RESIDENTIAL PROJECT REVIEW COMMITTEE (RPRC) APPLICATION

RESIDENTIAL PROJECT REVIEW COMMITTEE ENGINEERING REVIEW	
Date	August 14, 2020
Project Name	Joseph Daniel
Street Location	45 Byram Ridge Road
Section, Block & Lot	101.03/3/24
<u>Engineering Comments:</u>	
<p>1. The location of the property line should be clarified. There appears to be two similar lines offset with dimension pulled to each.</p> <p>2. The site plan shall illustrate the entire property limits.</p> <p>3. Provide an Existing Conditions Plan illustrating all features and those to be removed, including but not limited to, the residence, drive, walks, well, septic, overhead utilities, etc.</p> <p>4. Illustrate existing topography.</p> <p>5. The improvements within the Town right-of-way will require a Street Opening Permit from the Highway Department. All proposed improvements shall be detailed, per the Town Highway Department standards.</p> <p>6. The plan shall demonstrate that the minimum required Westchester County Department of Health (WCHD) setbacks to the infiltration system/domestic well/proposed improvements are met. The proposed storm connection for the slot drain is not shown on the plan. Assuming it will dis

STORMWATER POLLUTION PREVENTION AND EROSION CONTROL PLAN

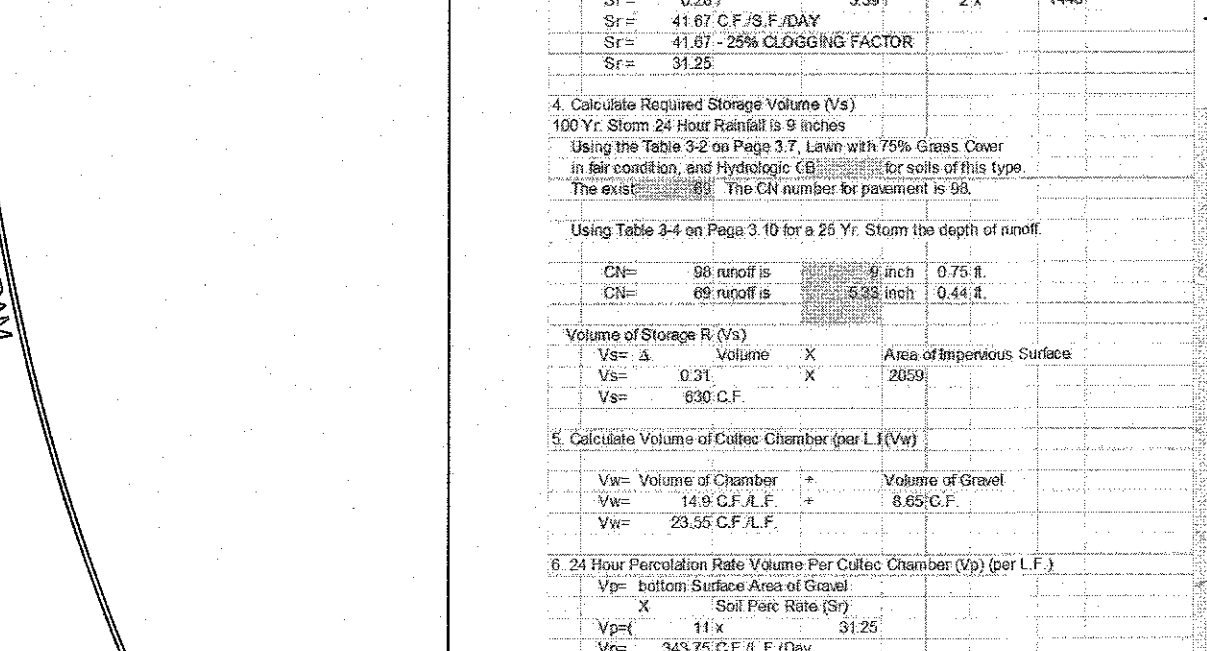
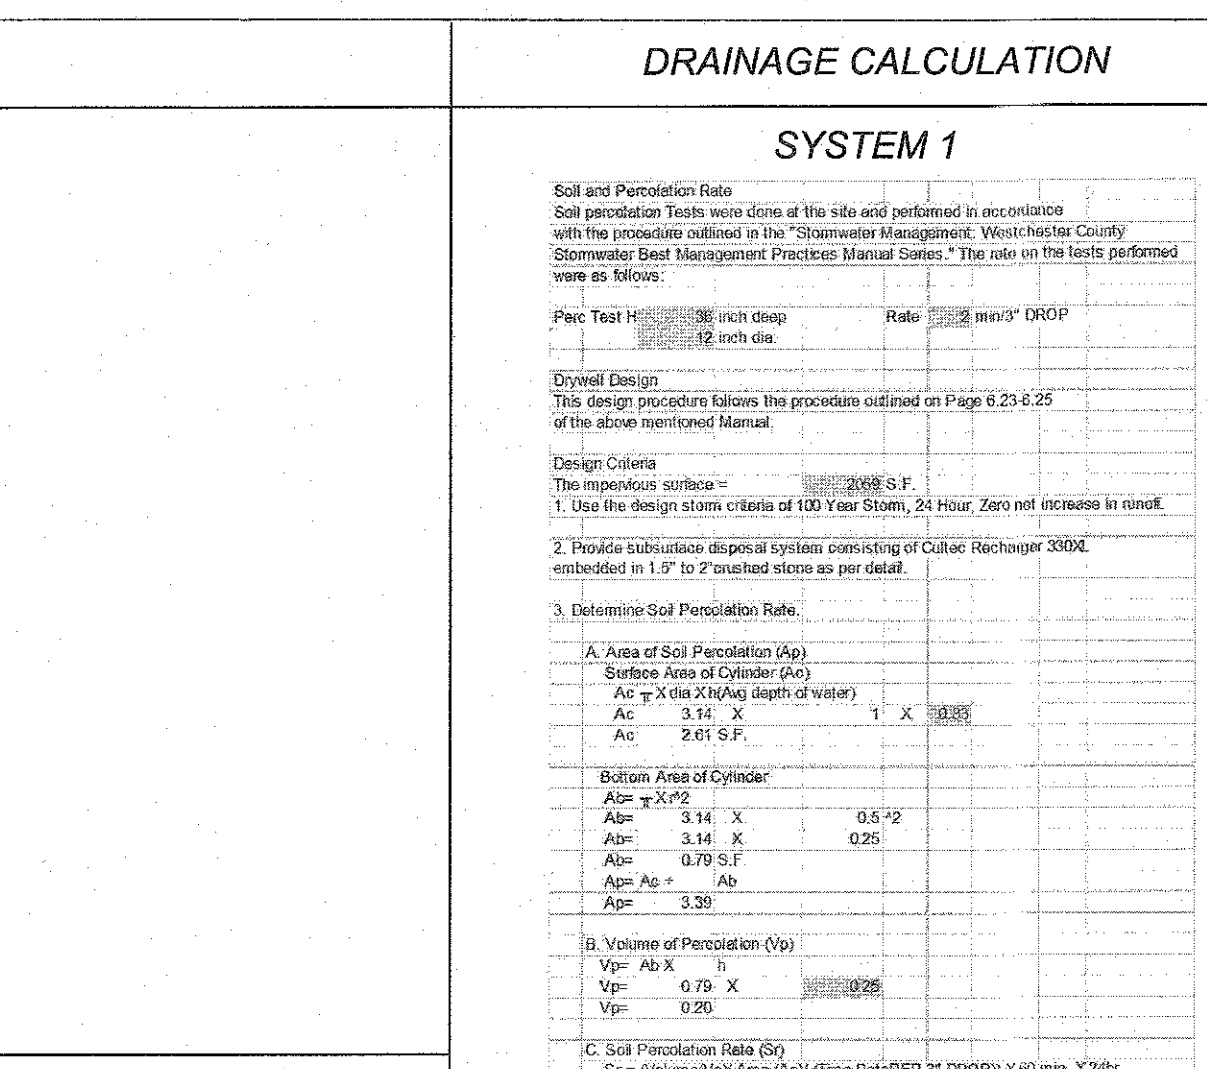
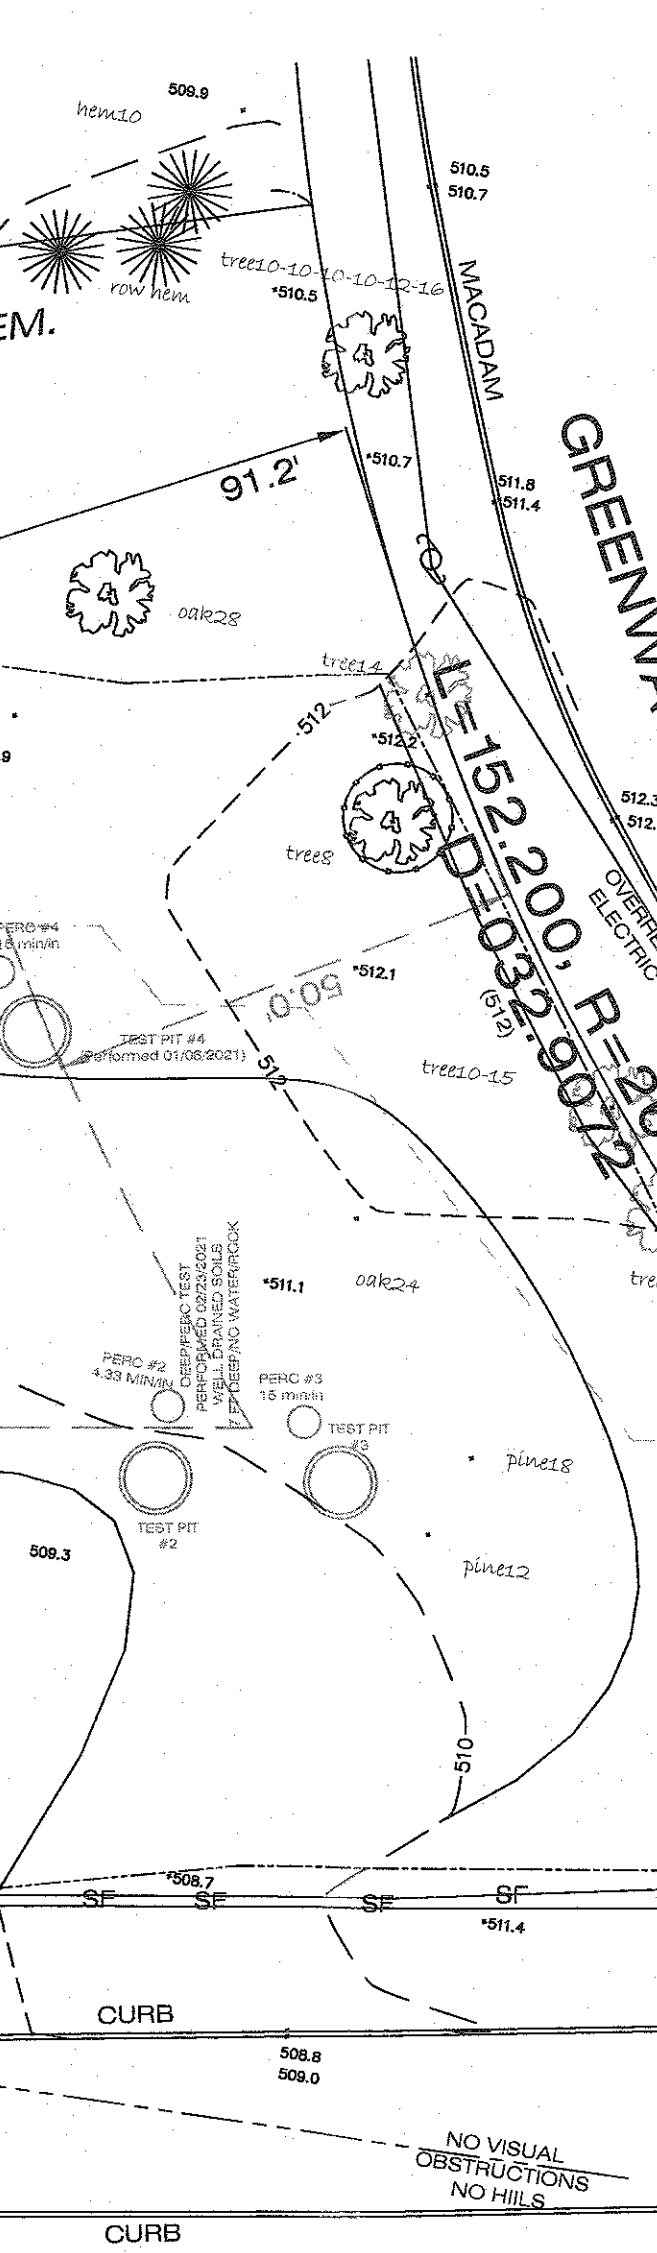
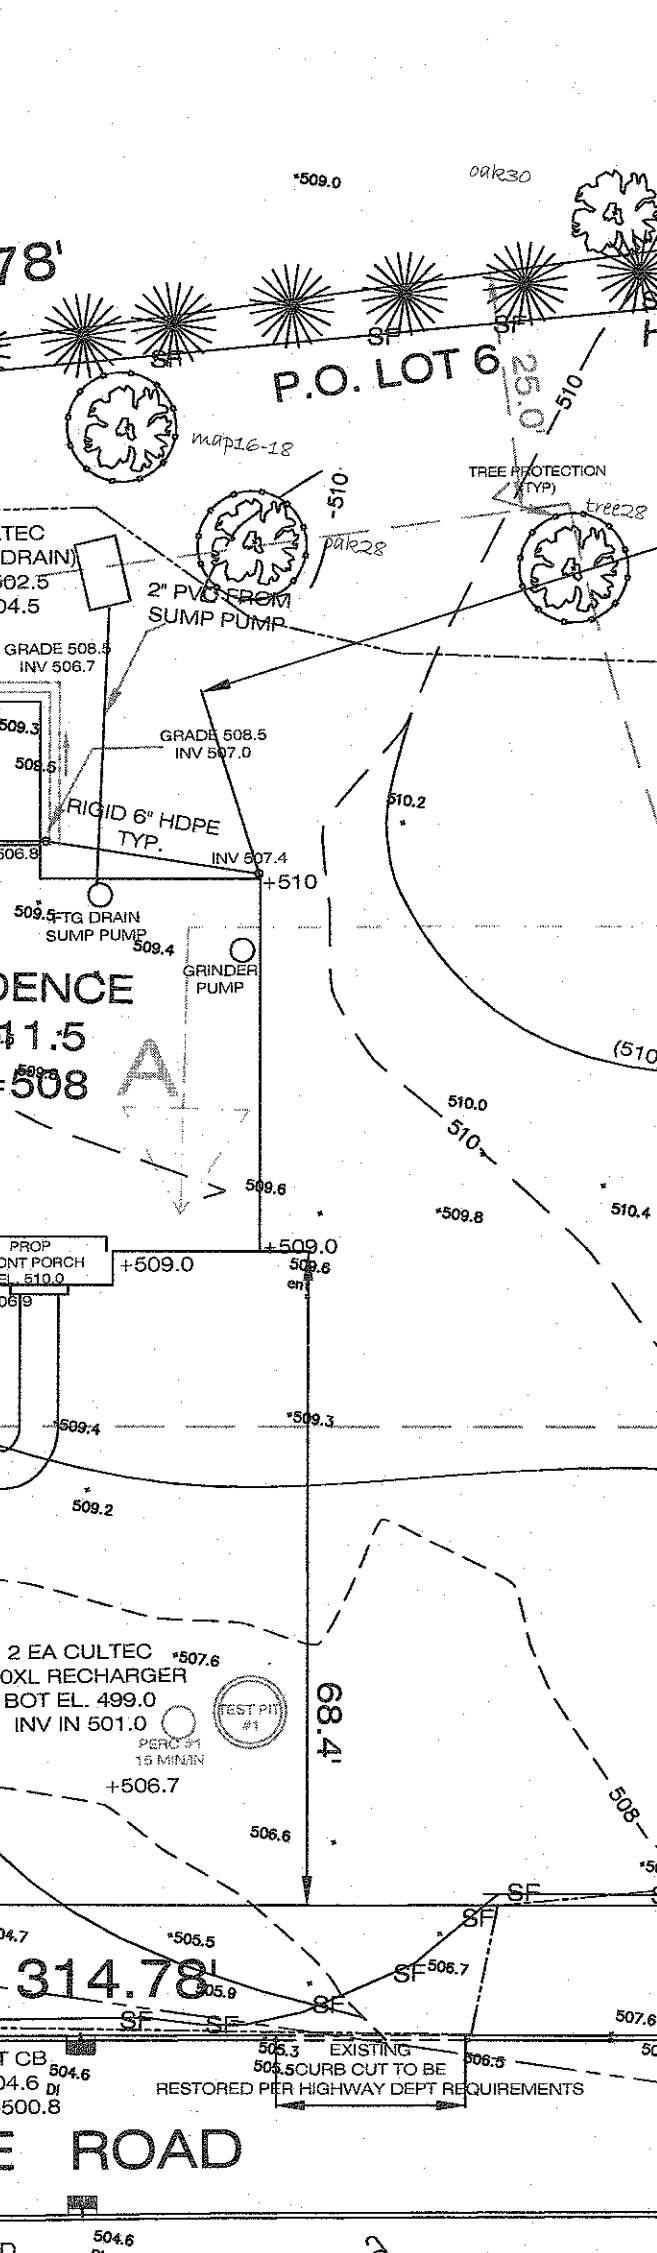
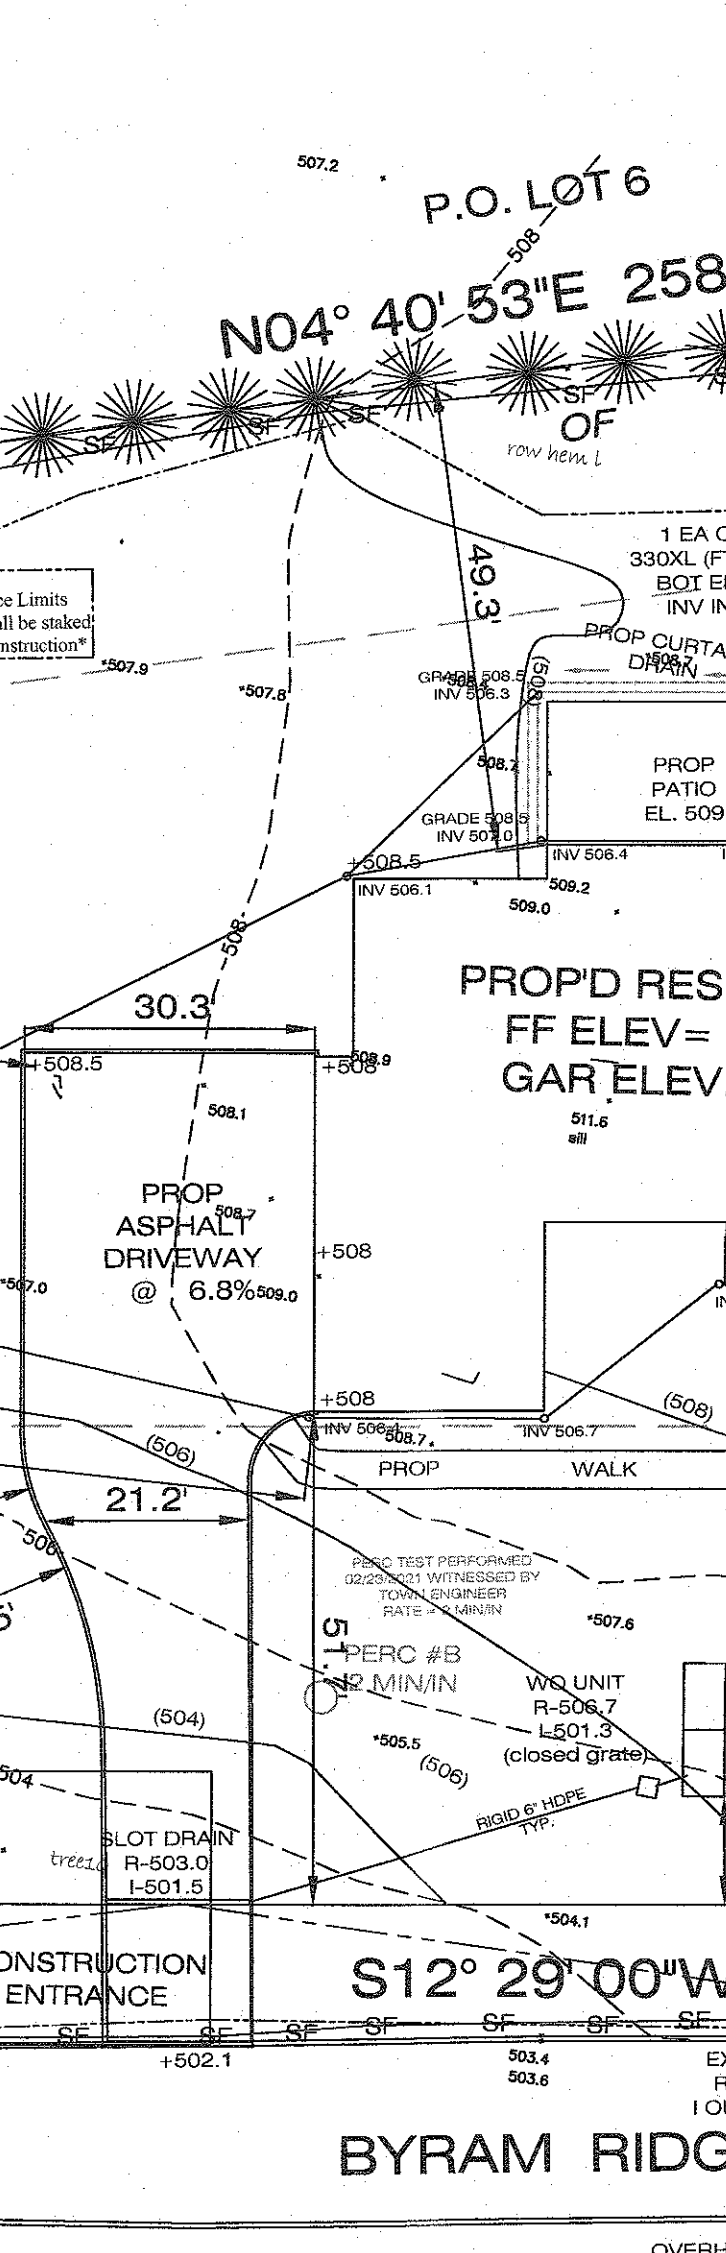
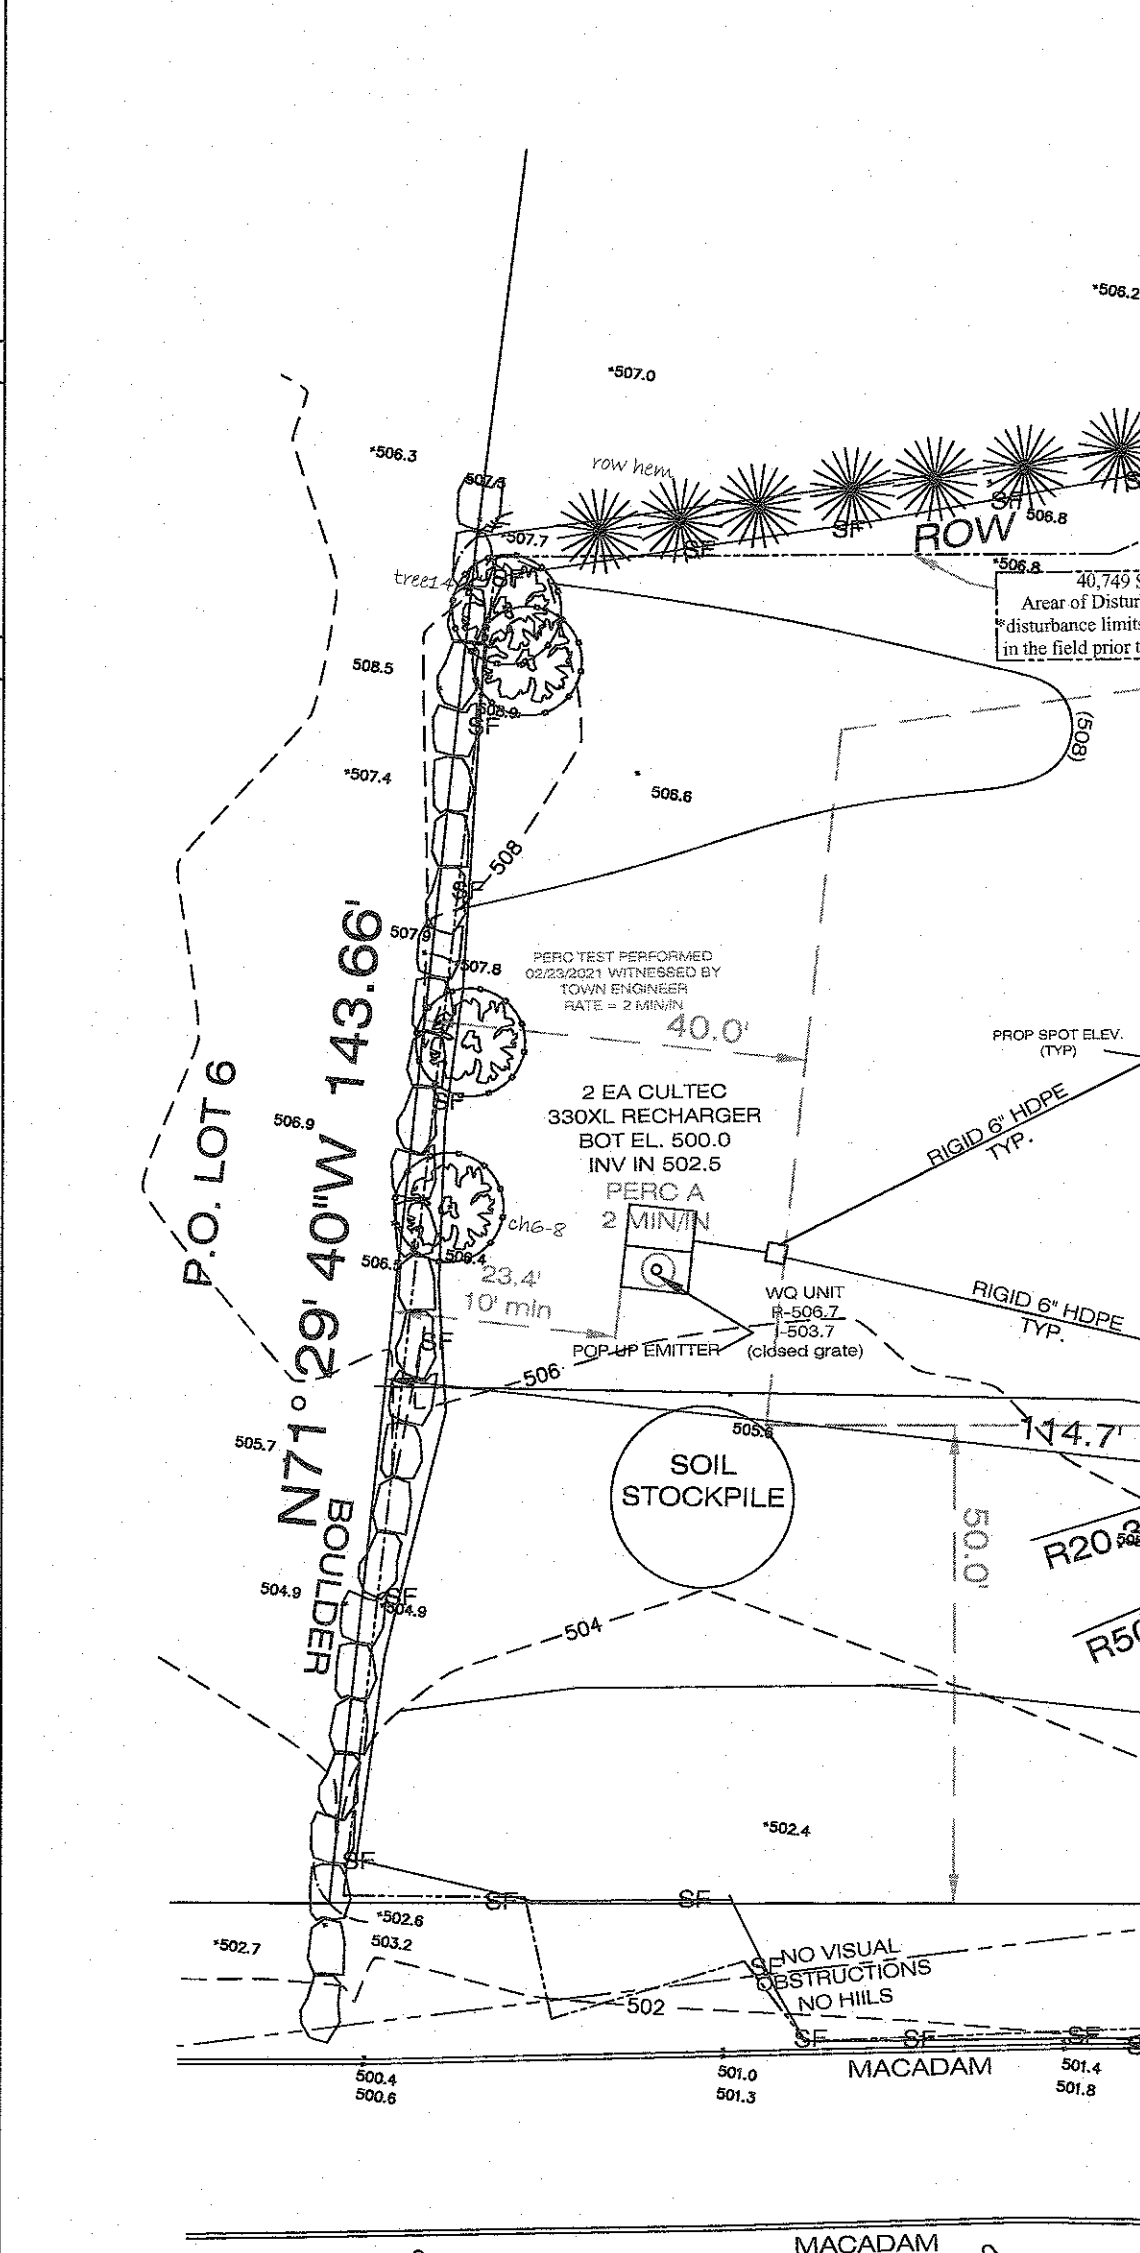
- As shown, it appears that at least two (2) additional trees will require removal in the vicinity of the infiltration system and associated grading, as well as 3-4 trees for the proposed septic field and grading. This should be reviewed and revised, as needed. The plan shall also clearly illustrate all existing trees to be protected.

- Provide a Landscape Plan.
- The proposed finished floor elevation is shown to only be six (6) inches above adjacent surrounding grade. Please verify and revise as needed.

- Provide stormwater mitigation and design calculations for the runoff generated by the net increase in impervious surface for the 100-year, 24-hour design storm event. Rainfall data shall be taken from the NRCS Extreme Precipitation Data.

- The plan should locate the proposed footing drain discharge, as well as the area drain for the exterior basement window wells.
- All proposed drain pipes, including the roof drain piping, should have a minimum of one (1) foot of soil cover.

- Provide construction details for the proposed pipe trenching, pavement, curbing and roof leaders.
- The Trench Drain Detail indicates a four (4) inch total height. However, six (6) inch diameter piping is proposed. The trench drain should be revised to accommodate the six (6) inch pipe and adequate cover.

- An emergency overflow control must be provided for the infiltration system.

- **All dimensions corresponding to WCHD requirements have been labeled.**
- The Slot Drain Detail does not seem appropriate for use in the drive. Please replace the structure with one suitable for H-20 loading.

- Noted and limits identified.
- The plan shall illustrate the areas of the proposed septic field and infiltration area to be cordoned off from construction traffic during construction.

- Fence shown.
- As shown, it appears that at least two (2) additional trees will require removal in the vicinity of the infiltration system and associated grading, as well as 3-4 trees for the proposed septic field and grading. This should be reviewed and revised, as needed. The plan shall also clearly illustrate all existing trees to be protected.

- Additional trees shown to be removed and tree protection shown
- Provide a Landscape Plan.
 - Landscape Plan Provided
- The proposed finished floor elevation is shown to only be six (6) inches above adjacent surrounding grade. Please verify and revise as needed.

- First floor elevation and grading revised
- Provide stormwater mitigation and design calculations for the runoff generated by the net increase in impervious surface for the 100-year, 24-hour design storm event. Rainfall data shall be taken from the NRCS Extreme Precipitation Data.

- Plan has been revised for a 100 year storm.
- The plan should locate the proposed footing drain discharge, as well as the area drain for the exterior basement window wells.

- Additional cultec provided for the footing drain discharge. Window well drain to be tied into footing drains.
- All proposed drain pipes, including the roof drain piping, should have a minimum of one (1) foot of soil cover.

- All piping now has 1 ft of cover.
- Provide construction details for the proposed pipe trenching, pavement, curbing and roof leaders.
 - Curbing and trench details are on the plan sheet

- The Trench Drain Detail indicates a four (4) inch total height. However, six (6) inch diameter piping is proposed. The trench drain should be revised to accommodate the six (6) inch pipe and adequate cover.

- Detail has been revised
- An emergency overflow control must be provided for the infiltration system.
 - Emergency overflow has been added (Pop Up Emitter)

The property is a corner lot. Pursuant to Section 355-15.I of the Town Code, on any corner lot, except in an R-5 District, there shall be provided a side yard on the side street equal in depth to the required front yard on said lot; therefore, the Byram Ridge Road side yard is required to have a 50 foot setback. The site plan will need to be revised.

The site plan should be revised to include a zoning conformance table.

- The location of the property line should be clarified. There appears to be two similar lines offset with dimension pulled to each.
- **Property line location corrected.**

- The site plan shall illustrate the entire property limits.
- **Site plan now illustrates the entire property limits.**
- Provide an Existing Conditions Plan illustrating all features and those to be removed, including but not limited to, the residence, drive, walks, well, septic, overhead utilities, etc.

- **Note added to existing curb cut.**
- The plan shall demonstrate that the minimum required Westchester County Department of Health (WCHD) setbacks to the infiltration system/domestic well/proposed improvements are met. The proposed storm connection for the slot drain is not shown on the plan. Assuming it will discharge to the infiltration system, we note that the WCHD requires a separation of 100 feet to a drilled well for infiltration systems collecting runoff from paved surfaces (drives). The plan shall be revised accordingly.

- **See new detail**
- Provide a copy of the WCHD Approval for the proposed modifications/replacement of the on-site wastewater treatment system and drilled well.

- Setback has been revised

- Zoning table has been added.
